2ND AND VIRGINIA

LPB PRIORITIES Meetings Recap

Meetings Responses

TSA PARTY WALL ELEVATION CHANGES
RE-WORKED WINDOW PATTERNING + SCALE

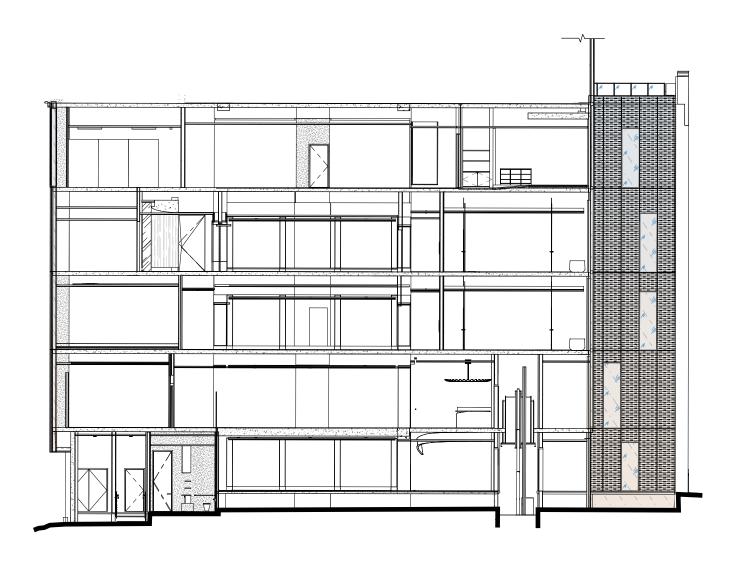
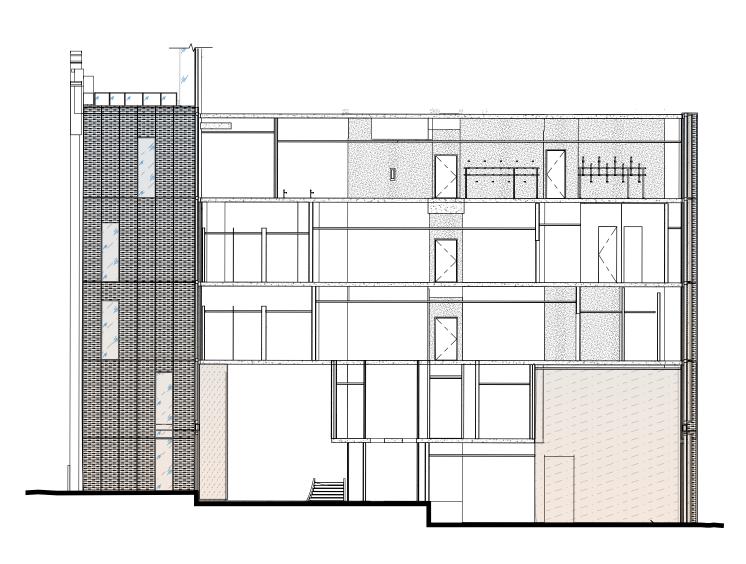
1 Tower Expression should draw inspiration from Landmark

Match Existing Levels of Landmark

Floors levels should remain the same behind the Landmark. These elevations are important at the windows.

TSA PARTY WALL SOUTH SECTION / ELEVATION

TSA PARTY WALL NORTH SECTION / ELEVATION
